**AGENDA
TOWN OF PITTSFORD
PLANNING BOARD
JANUARY 13, 2025**

**TOWN OF PITTSFORD
PLANNING BOARD
RESOLUTION
300 Tobey Village Road (Pittsford Oaks)
Preliminary Site Plan & Preliminary/Final Subdivision
Tax Parcels #163.02-1-24.111, 163.02-1-23.1, 163.02-1-36
Tobey PUD Parcels #8, 12, 7**

Re: Letter of Intent
Warfle Subdivision
74 East Park Road, Town of Pittsford, NY

TOWN OF PITTSFORD
DEVELOPMENT REVIEW COMMITTEE – Planning Comments
For Planning Board Meeting 1/13/25

Pittsford Oaks – Design Reviews Progressions

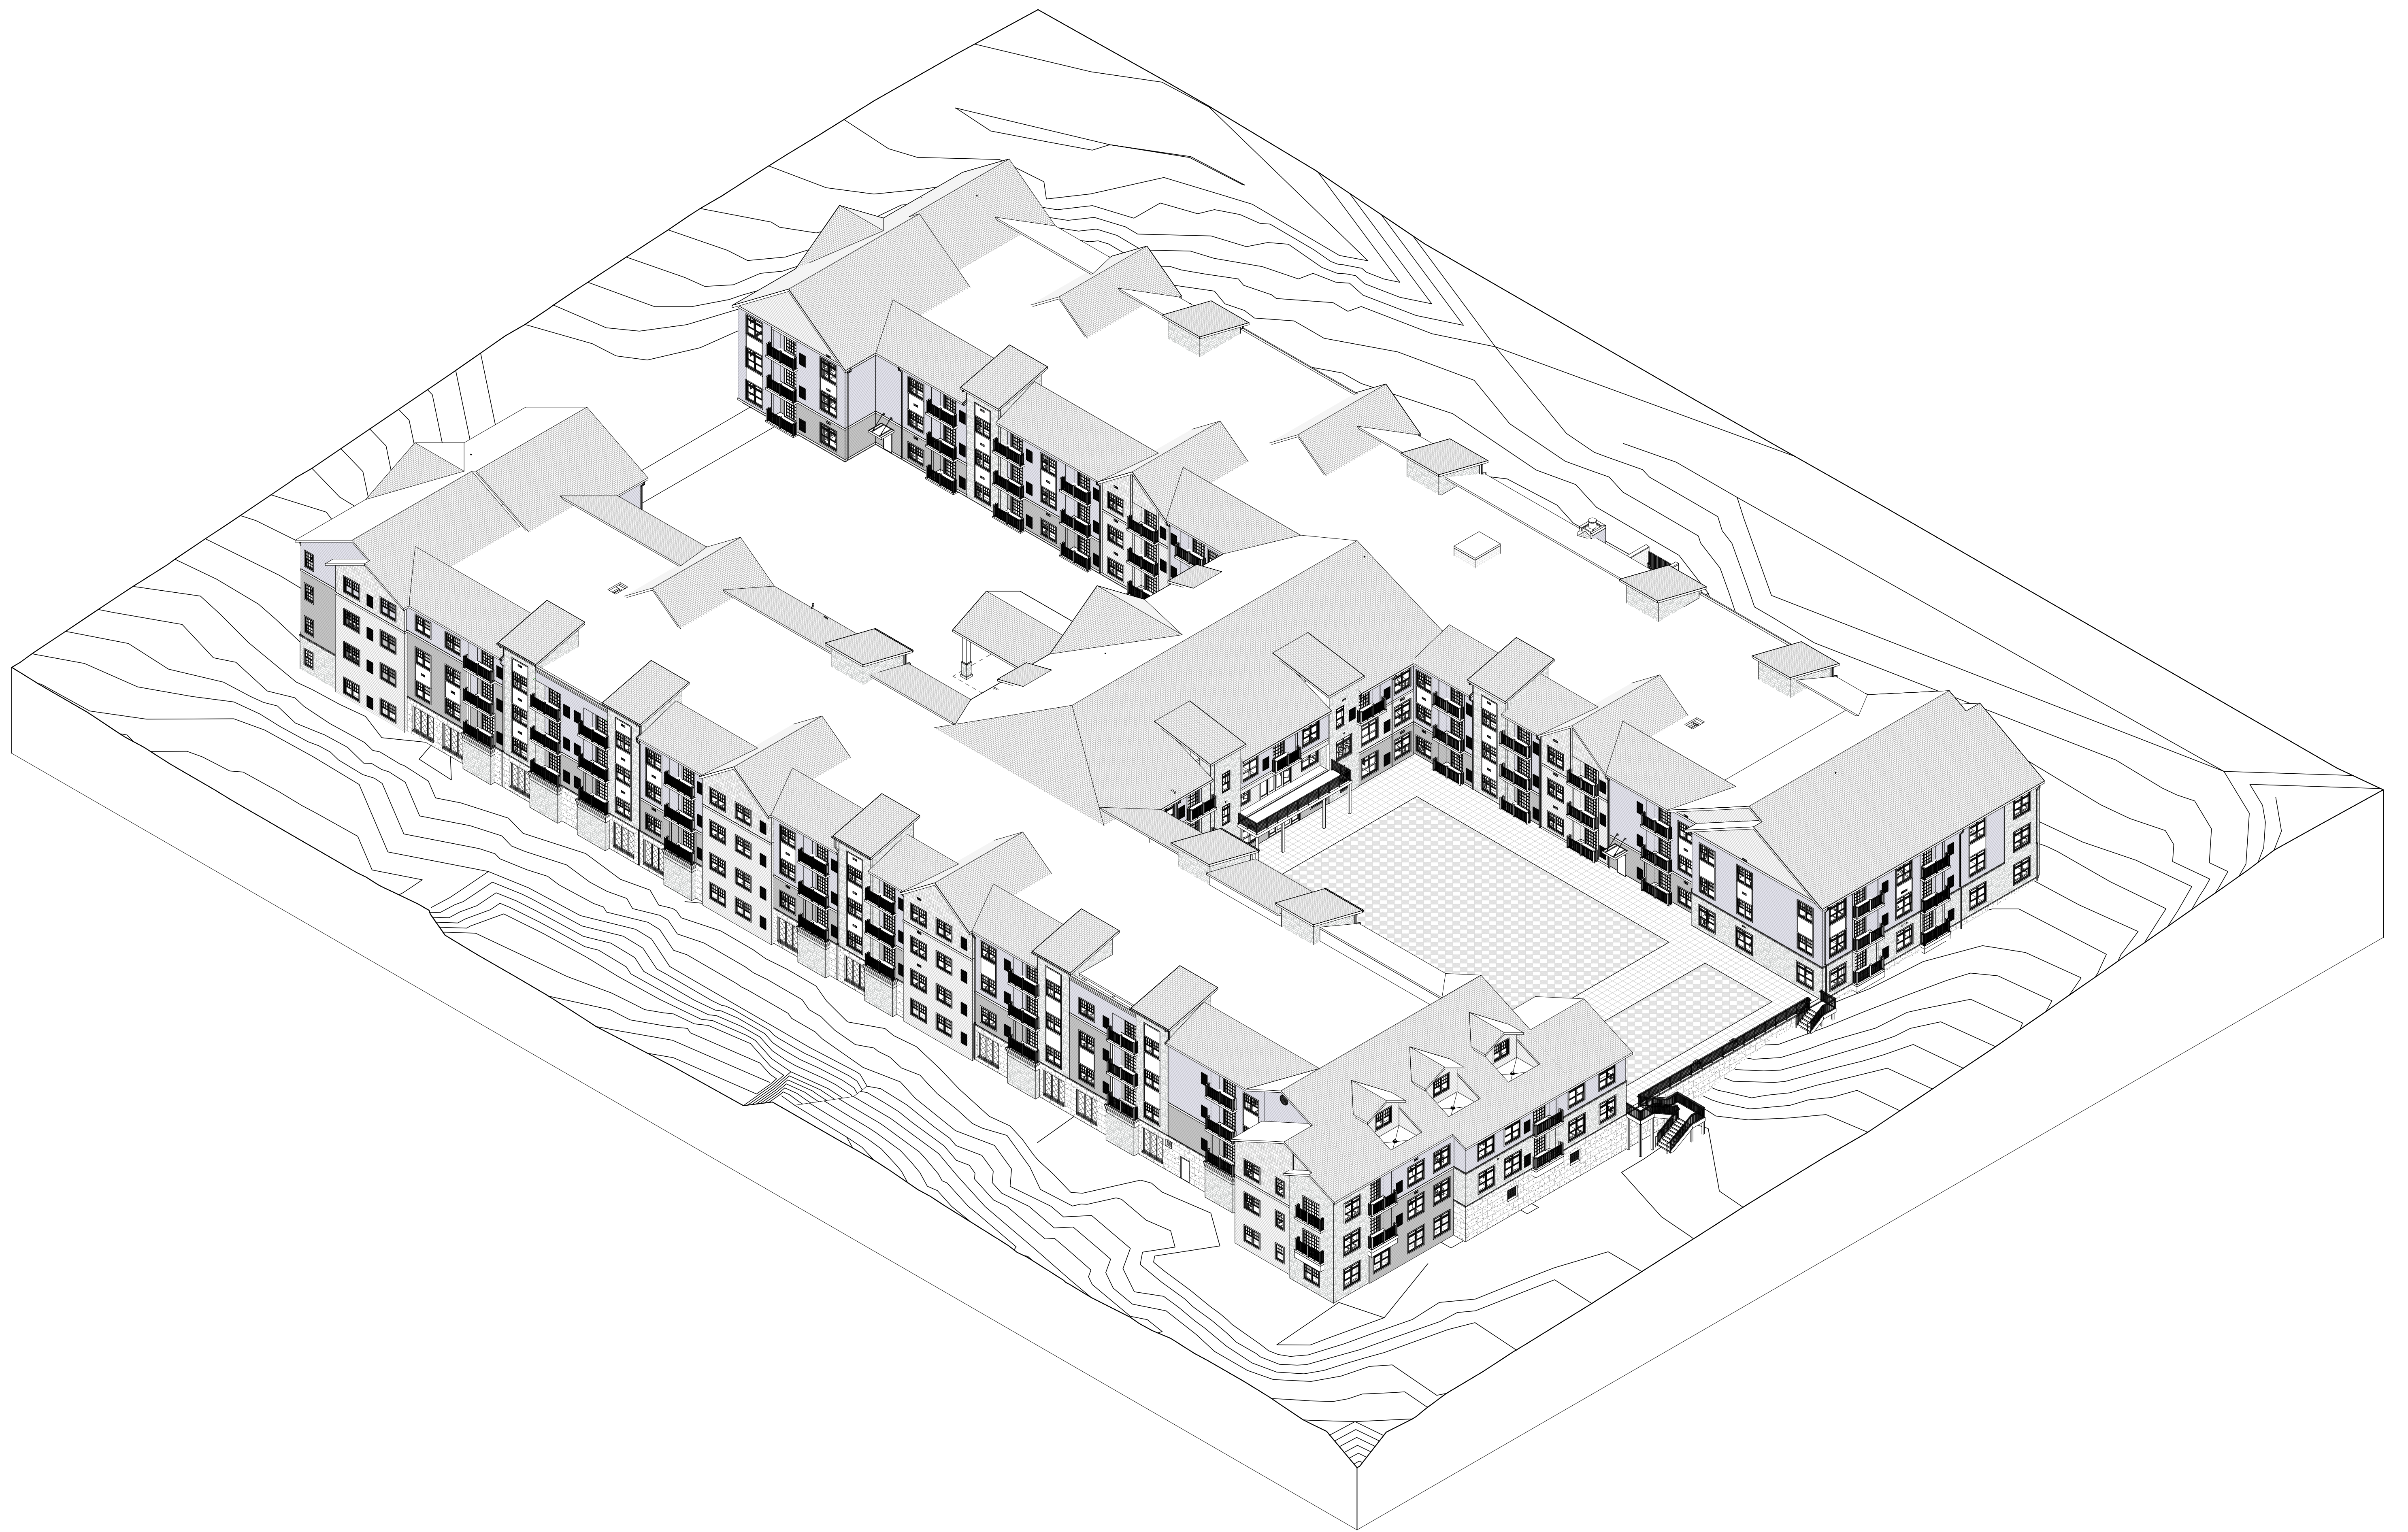
15. The size, scale, and mass of the building was relatively unchanged from the original Town Board submission in November 2023. The DRHPB has identified building characteristics that can be modified to help address those concerns. The DRHPB provided the following comments from their September 12, 2024 meeting in regard to changes that would reduce the building's impacts:

16. The applicant appeared again before the DRHPB on October 10, 2024, and building adjustments were discussed and modified renderings were presented. The following comments were generated by the DRHPB on October 22, 2024, and forwarded to the applicant on October 23, 2024:

- A.** *After further discussion and reflection at the board meeting, we hope the Planning Board will hold off on preliminary approval until the developer submits at least one more round of elevations.*

18. The applicant revised the building elevations and made a presentation at the December 5th DRHPB meeting. There was Board consensus that the design was moving in the right direction and that the latest elevations depicted the best iteration of the building to date. However, the Board was divided between those who were confident that further design modifications made after the Planning Board grants Preliminary Site Plan approval for the project would be acceptable to the DRHPB during its formal review process, and those who felt that more big moves to reduce the overall mass of the building were needed before the DRHPB could recommend that the Planning Board should move forward with vote on Preliminary Site Plan approval.

19. The applicant revised and returned at the December 19, 2024, DRHPB meeting. Changes to the elevations included the introduction of decorative elements at the garage level, the use of more flat roofs, and the addition of more design changes to break up the uniformity of the building's facades. The Board commented that while it recognized that the changes made were in the right direction, the changes made were minimal and served to make the building appear smaller than it actually would be. Bigger moves and bigger reductions, the Board opined, could go a long way in showing how the massing and volume of the building could be reduced.

20. The Planning Board acknowledges that progress has been made on the scale and massing of the building but supports additional modifications that may be required by the DRHPB that will further reduce the scale and massing of the building.

3 SITE SECTION - THROUGH EAST WING AT EXISTING ADJACENT BRICK BUILDING
0' 4' 8' 16' 32'
1/16" = 1'-0"

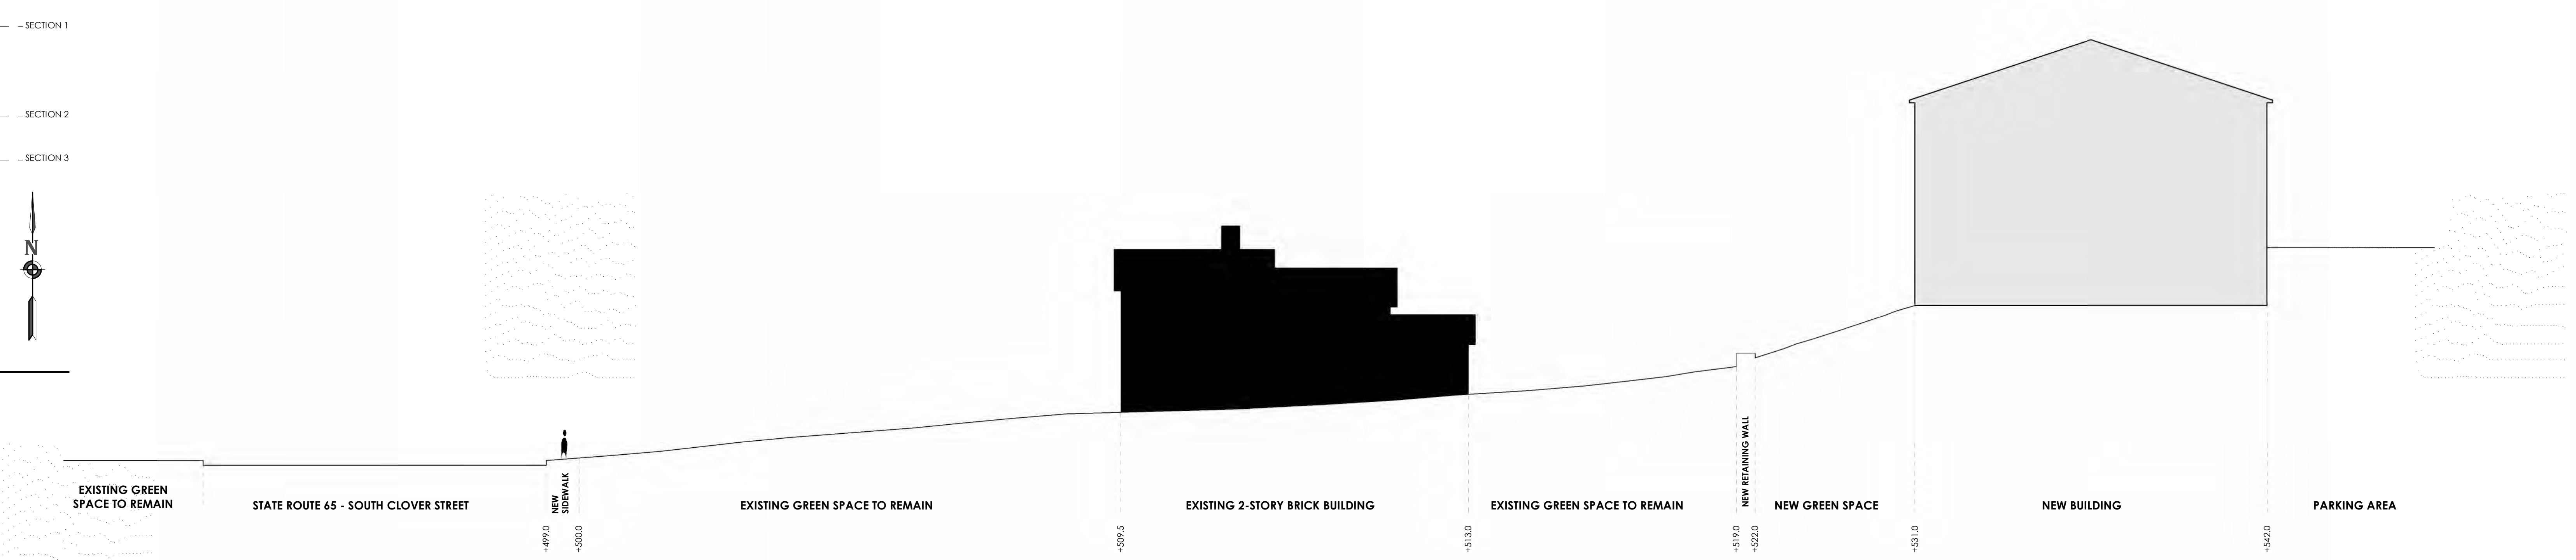
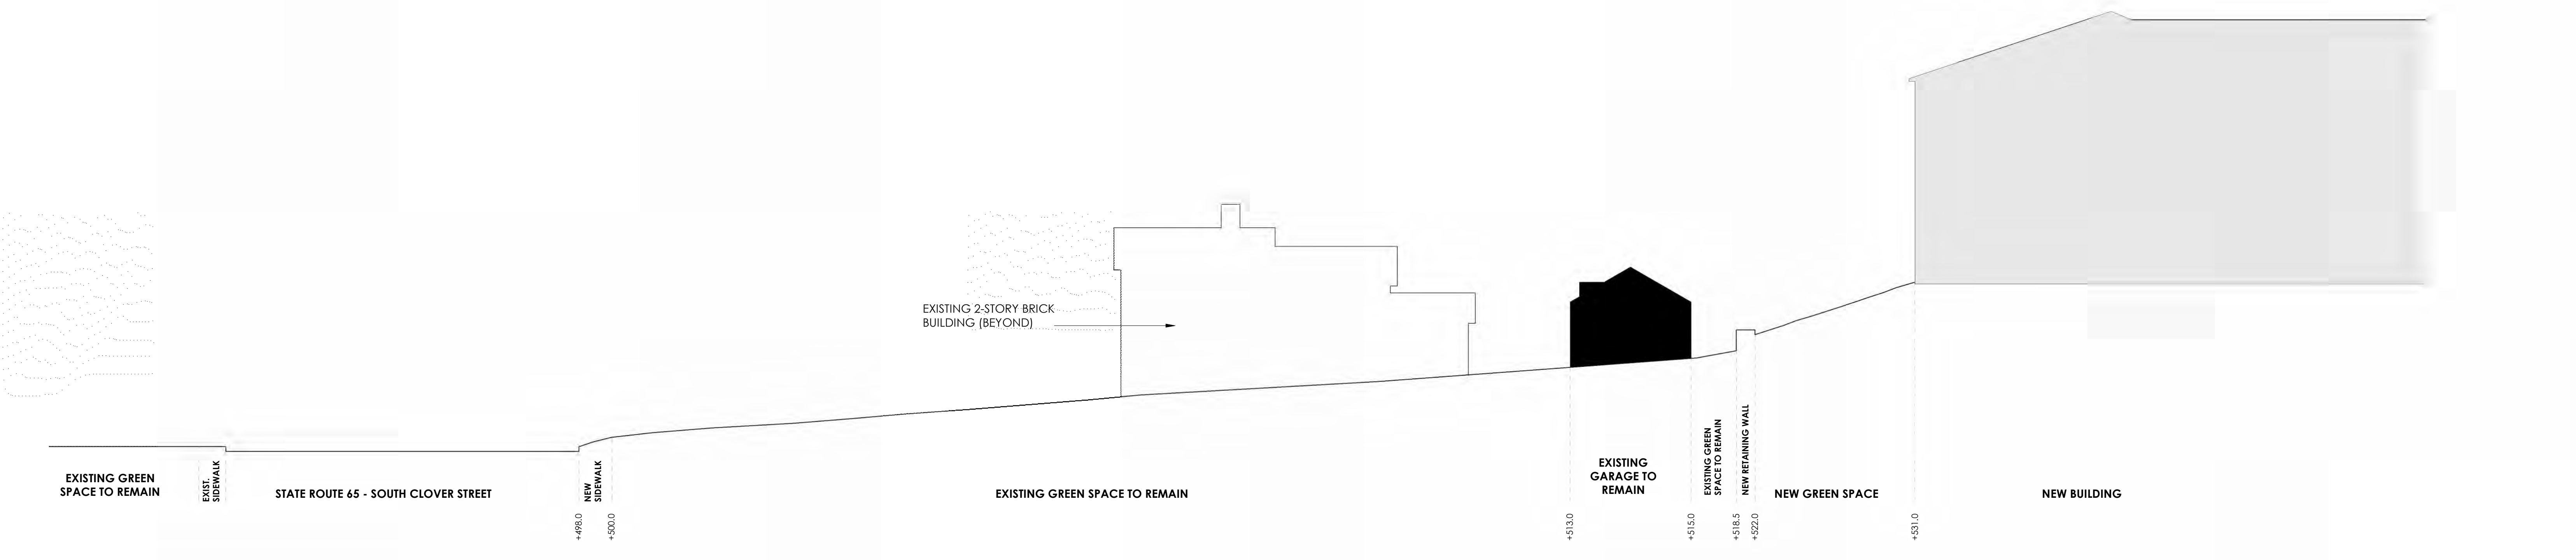
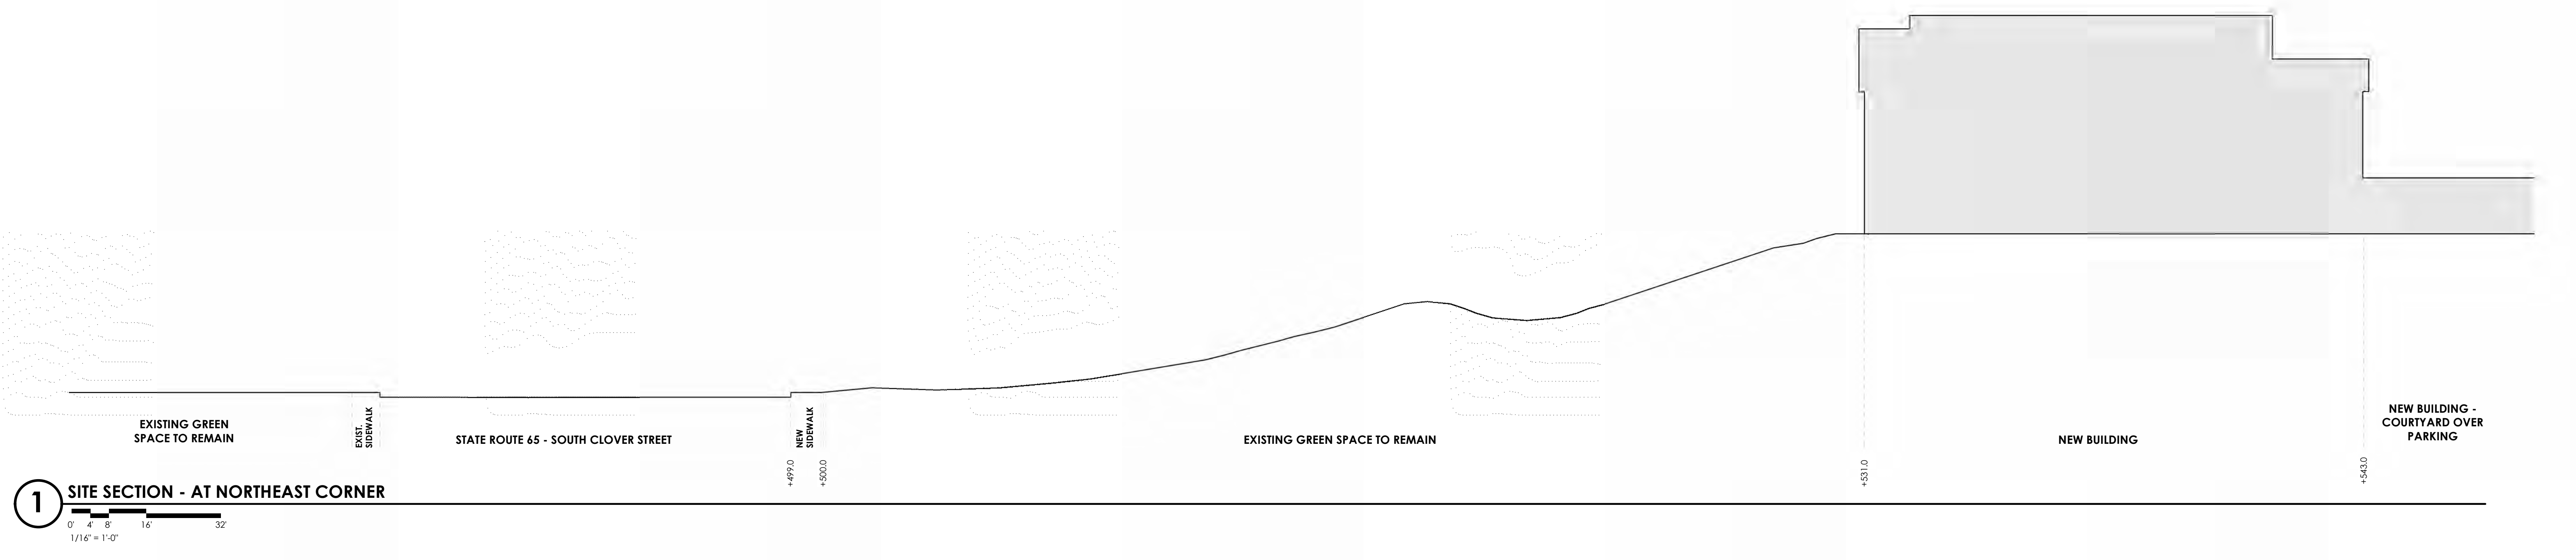
- I. *Provide a site section from Clover St. through the historic property depicting the historic home in elevation including the garage elevation, through the entire project site including the bank building on the west side.*
